Project Union – 7511/APP/2022/1007 S96A(2)

HDR Technical Notes

Bulls Bridge Industrial Estate, Hayes, UB3 4QQ

Date:	April 2023	Issue:	02
Reference:	HPF-0571-ZZ-ZZ-RP-MEP-00001	Status:	Issue
Prepared by:	Gabiela Krebs	Date:	17/04/2023
Edited by:	Ulrich Groenwald	Date:	18/04/2023
Authorised by:	John Foreman	Date:	19/04/2023
Issuing office:	Croydon

Figure: Old Generator layout at Energy Centre 3 for 2022 Slot-In Application – 'NWA-0571-EC3-ZZ-DR-A-03-005P – EC3 Floor Plans'

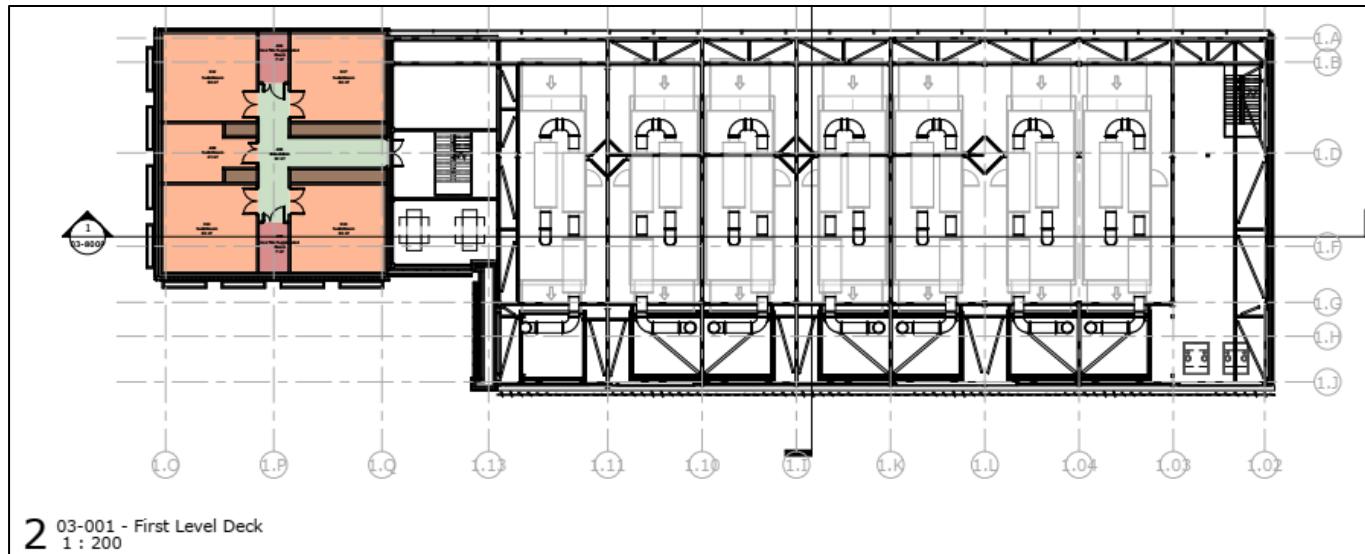
The need for this technical note has arisen due to proposed minor changes to the locations of diesel generator exhaust flues at Energy Centre 3 (EC3). As shown in NWA's Drawing '*NWA-0473-DR-ZZ-M3-A-03005P – EC3 Floor Plans (Rev: P02)*', some of the diesel generators have been reorientated, thus requiring some exhaust flues to be shifted from the locations assessed within the 2022 slot-in planning application (NWA's Drawing '*NWA-0571-EC3-ZZ-DR-A-03-005P – EC3 Floor Plans*'). Extracts from the two drawings showing the changes in orientation are appended to this technical note.

The largest change in annual mean NO₂ concentrations as a result of the proposed EC3 alterations was predicted at R4 to the west; a future residential unit at the former Nestle Site. This is to be expected, as the proposals are to relocate several exhaust flues further north and west. The NO₂ process contribution (PC) of 0.20 µg.m⁻³ is anticipated to increase the predicted environmental concentration (PEC) to a total of 35.13 µg.m⁻³, which is below the annual mean UK Air Quality Standard by more than 12%.

The largest change in hourly mean NO₂ concentrations as a result of the proposed EC3 alterations was predicted at R18 to the west; a future residential unit at the former Nestle Site. This is to be expected, as the proposals are to relocate several exhaust flues further north and west. The NO₂ hourly process contribution (PC) of 14.3 µg.m⁻³ is anticipated to increase the predicted environmental concentration (PEC) to a total of 84.3 µg.m⁻³, which is still well below the 200 µg.m⁻³ hourly mean UK Air Quality Standard.

Results have clearly demonstrated that the relocated exhaust flues will have no material change to the pollutant concentrations predicted previously for the 2022 slot-in application.

As such, it is reasonable to state that the original conclusions of insignificance still apply. The proposed design changes to EC3 are predicted to have no significant impact on air quality.

EC2 Building

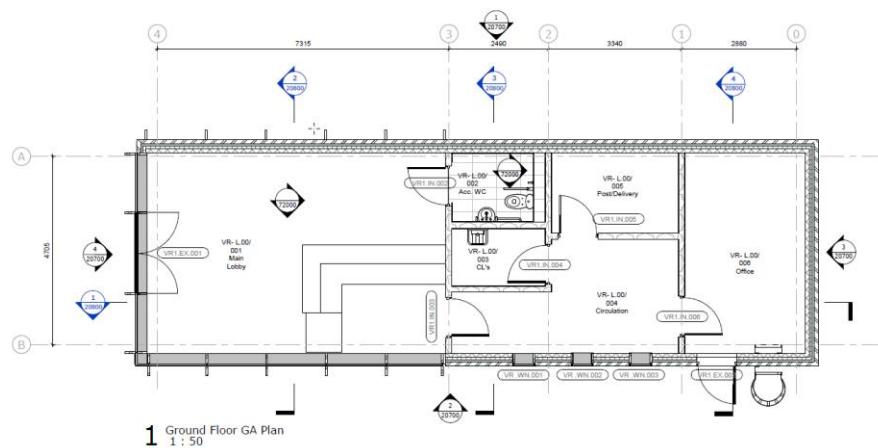
- Alterations to EC2 – the addition of external stairs (screened), the reversal of the heat rejection stacks & the creation of additional GF apertures.
- VRC1 reduced from 2 floors to 1 floor.
- Changes to the towpath and VRC car parking arrangement,
- Alterations to EC3 relating to the green wall arrangement.

- Alterations to EC2 – the addition of external stairs (screened), the reversal of the heat rejection stacks & the creation of additional GF apertures.
- VRC1 reduced from 2 floors to 1 floor.
- Changes to the towpath and VRC car parking arrangement,
- Alterations to EC3 relating to the green wall arrangement.
